CHANGE ORDER NO. 1

DATE: July 28, 2026
OWNER: Boone County Regional Sewer District
CONTRACTOR: SSSC, Inc.
ENGINEER: Cochran
SUBJECT: Change Order No. 1
 Sanitary Sewer Extension at Highfield Acres WWTF
 Cochran Project No. LOR15-062

SANITARY SEWER MAIN #1 STA. 8+10 - STA. 15+19
DATE: 02/09/26
BY: ADK
CHECKED: WRJ
APPROVED: WRJ
DATE: 03/05/26
FEB. 2026
HORIZ. SCALE: 1"=30'
VERT. SCALE: 1"=10'
PROJECT NO.: LOR15-062
DWG. NO.: C3

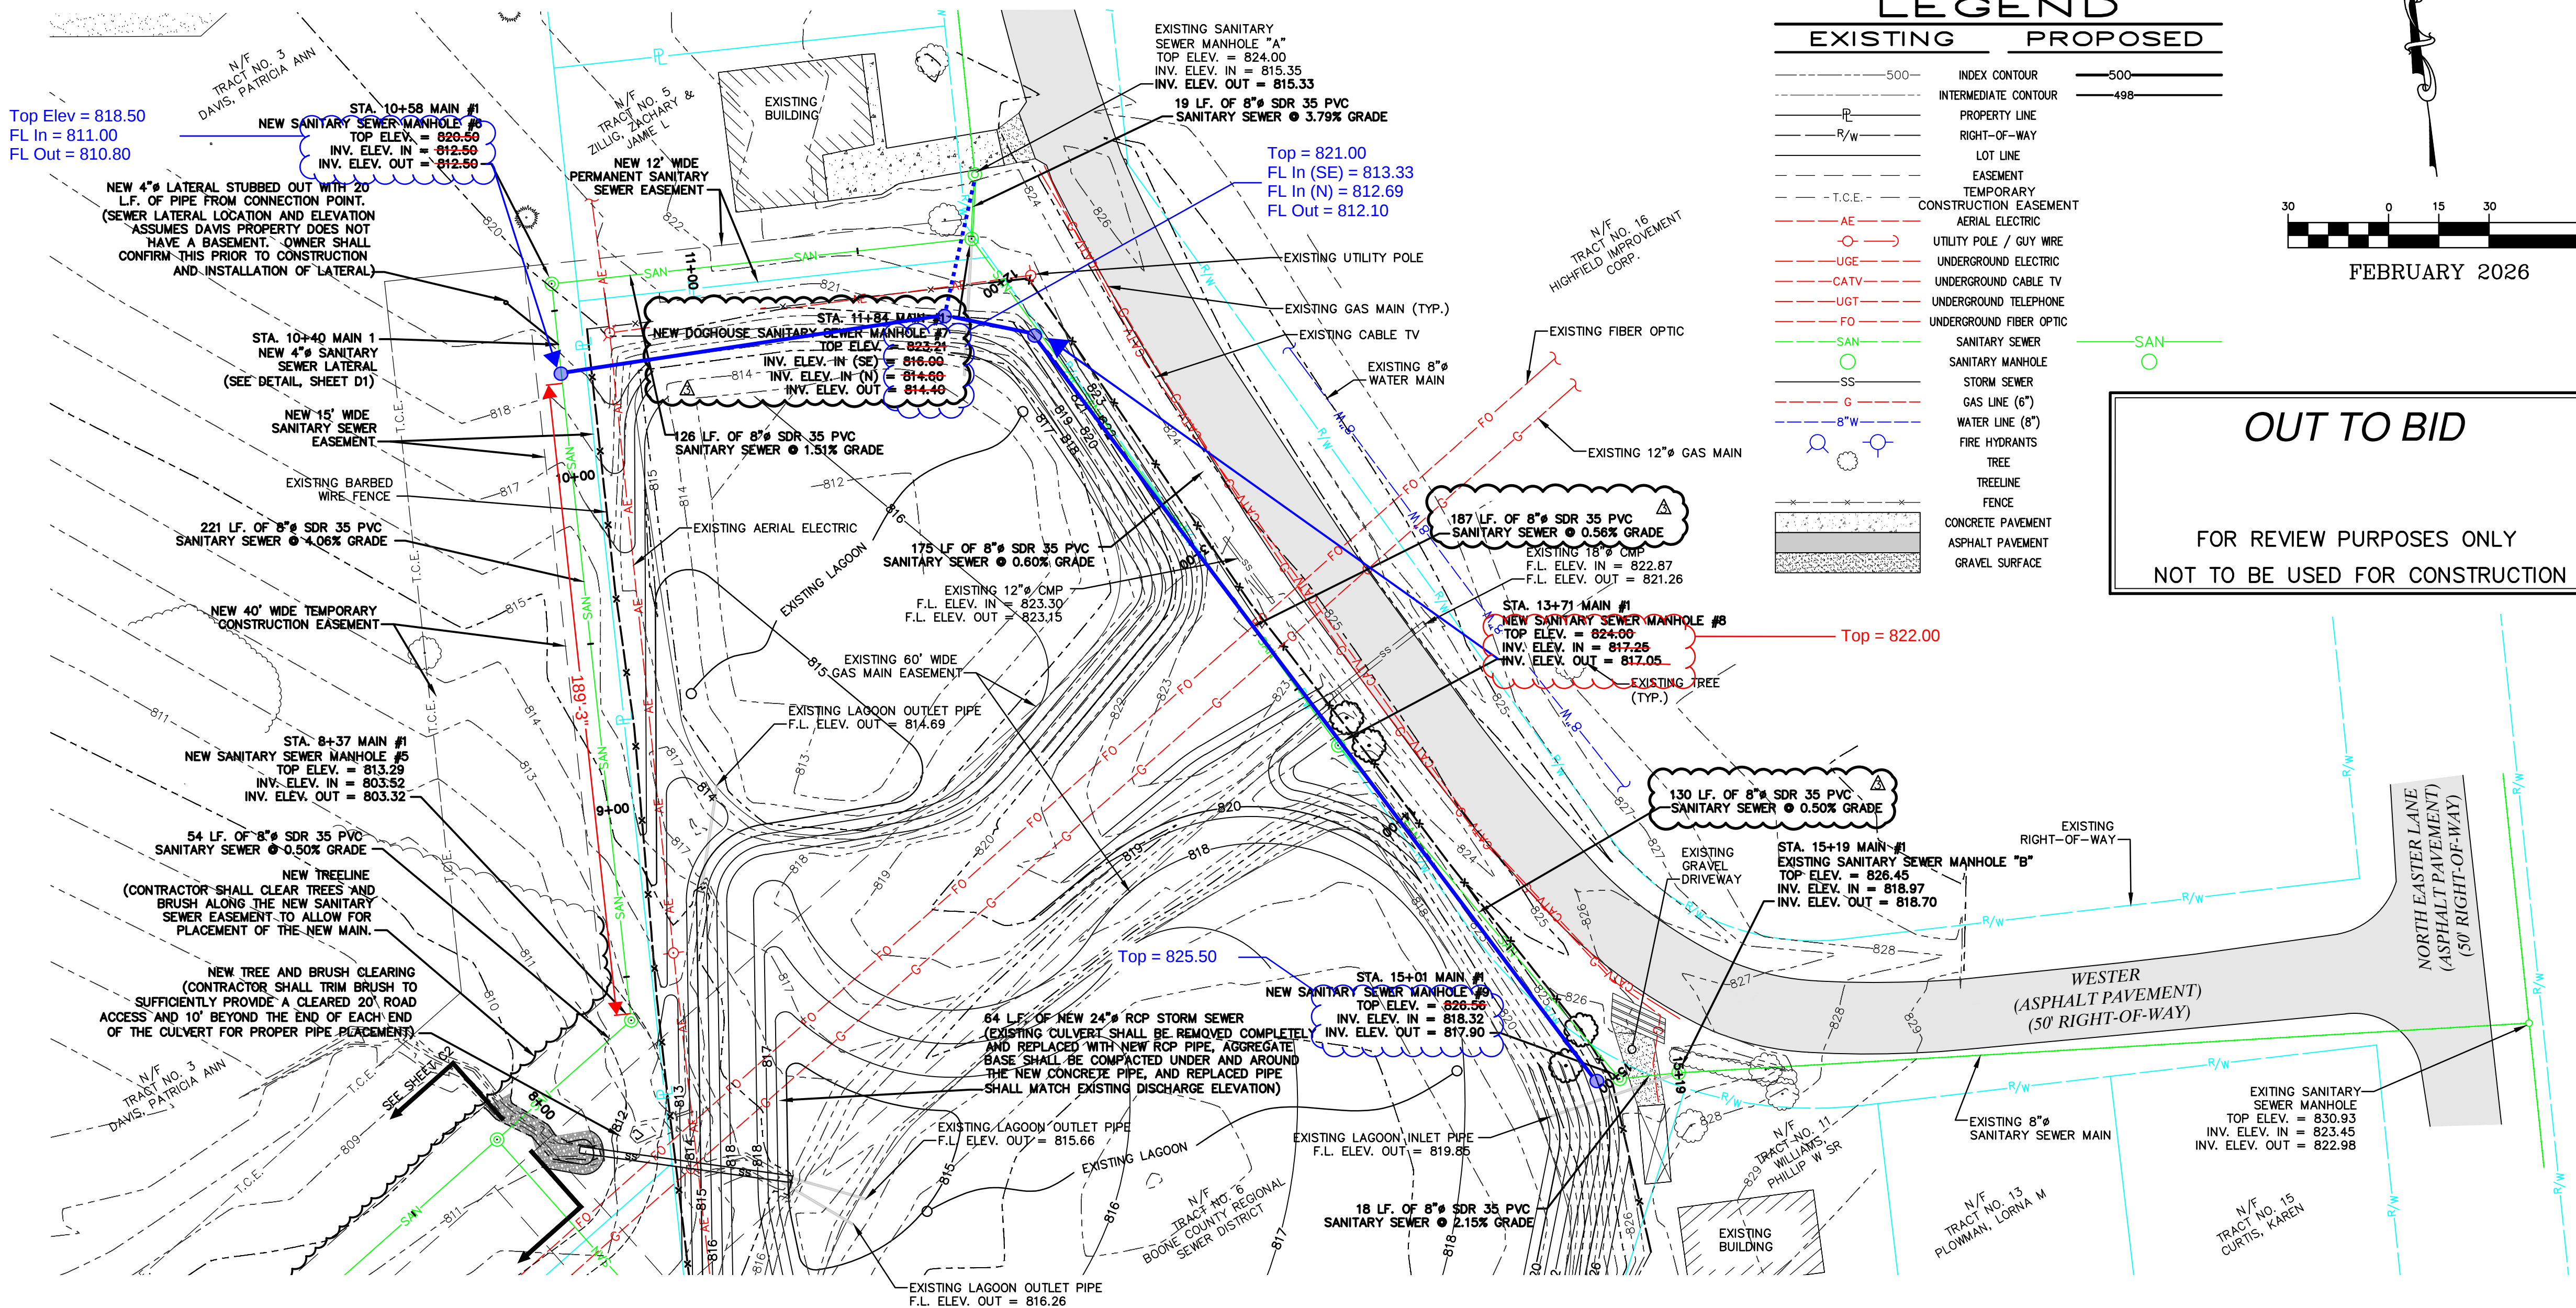
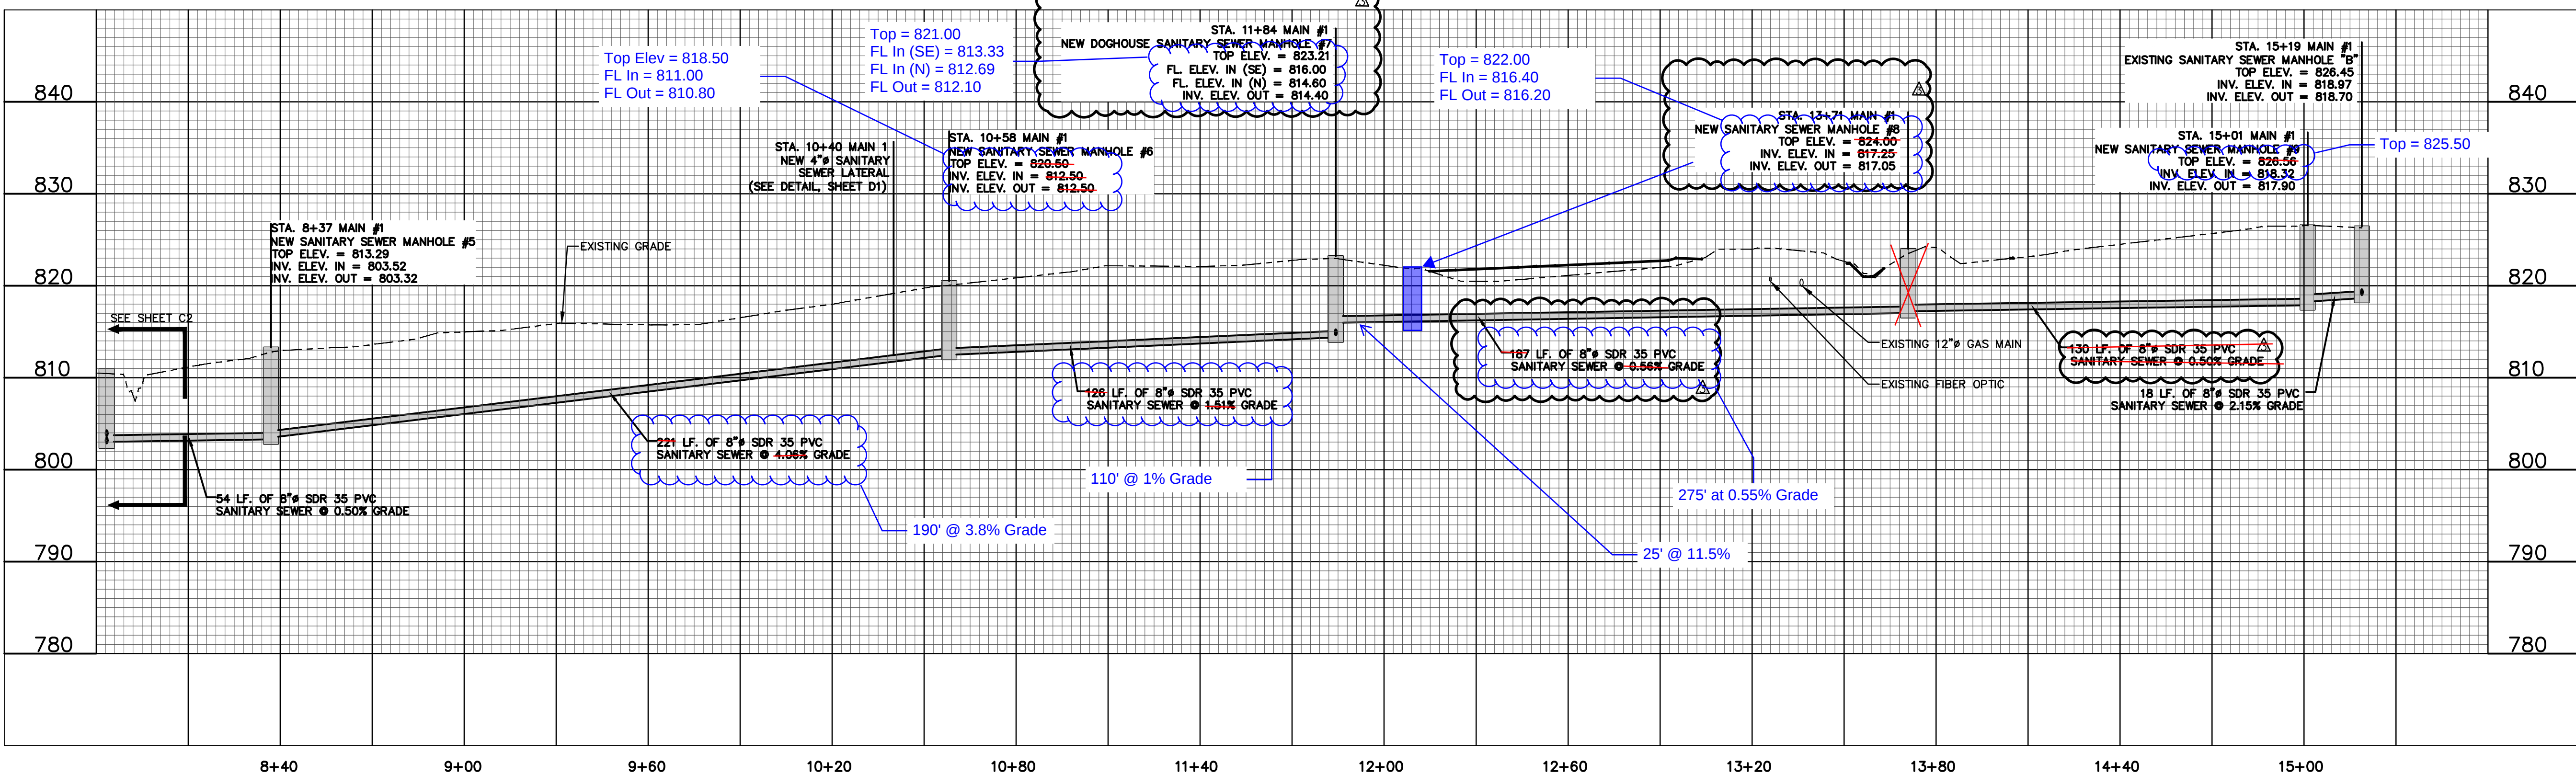
1. Per discussions and request the below changes are being made to the contract work:
 - a. Main #1 alignment and elevation revisions per the attached plans. Revisions made due to main potholing.
 - b. Main #2 alignment and elevation revisions per the attached plans. Revisions made due to main potholing.
